FRONT VIEW-SECTION 3C06

DES. NO.	TITLE
E-1713	FRONT VIEW-SECTION 3C06
E-1714	FRONT VIEW-SECTION 3C06
E-1715	TOP VIEW, SECTIONS A-A, B-B
E-1716	SIDE VIEW, SECTIONS C-C, D-D, E-E
BM-1715-4	BILL OF MATERIAL
AE-1779	LIST OF NAMEPLATES (BEHIND PANELS, M-384)
C-5626	PLAN ELEVATION OF PANELS & CONSOLE LAYOUT
AE-1770	LIST OF NAMEPLATES (DIAGRAM LIGHTS)

Docket # 80-250
Control # 850340267
Date 02-10-85 of Document
REGULATORY DOCKET FILE

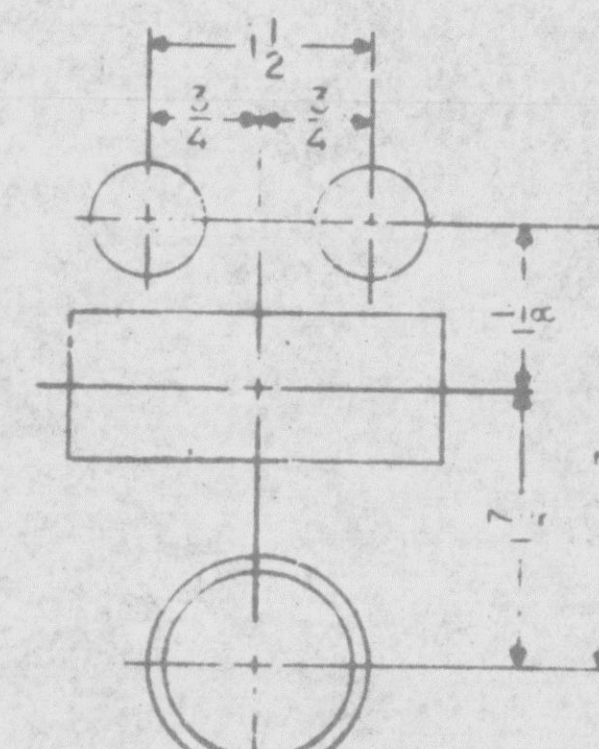
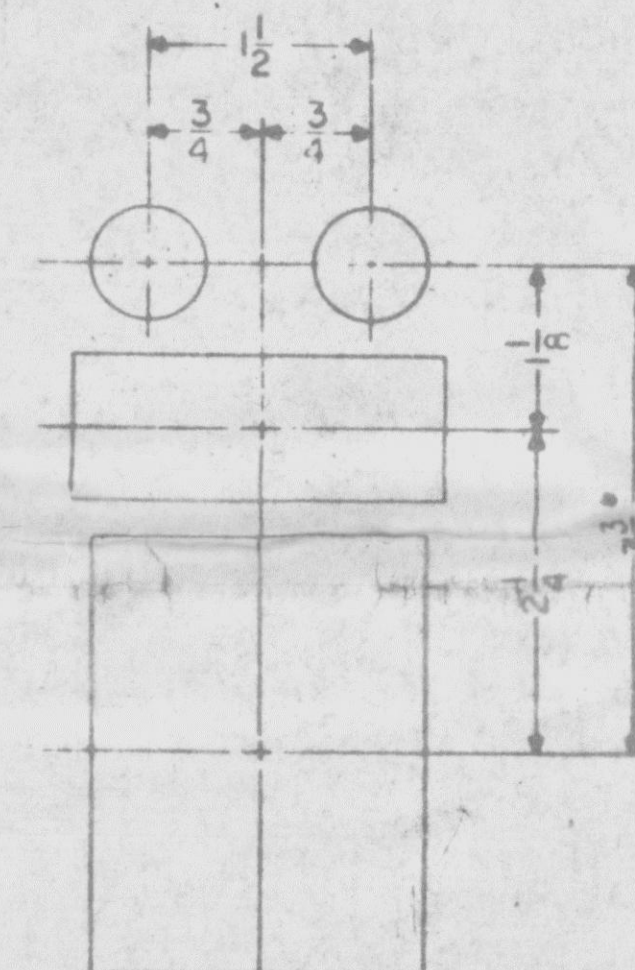
CHG'S. TO HIS FUNCTIONS PER REA-TPN-140	MARK NO.	EXISTING	FUTURE	NEW SWITCHES
81	516	SV-3-2913	SV-3-2913	
50	SV-3-2913:855	SV-3-2912:2311	CV-3-2821	855
79	SV-3-2912:2311	CV-3-2821		
78	CV-3-2821:2822	CV-3-2822		
77	CV-3-2819:2826	CV-3-2819		
76	CV-3-2803	CV-3-2826		
82	4659A	CV-3-2803	4659A	
83	4659B	516	4659B

RELOCATED SWITCHES
HIS-3-855
HIS-3-4659A
HIS-3-4659B
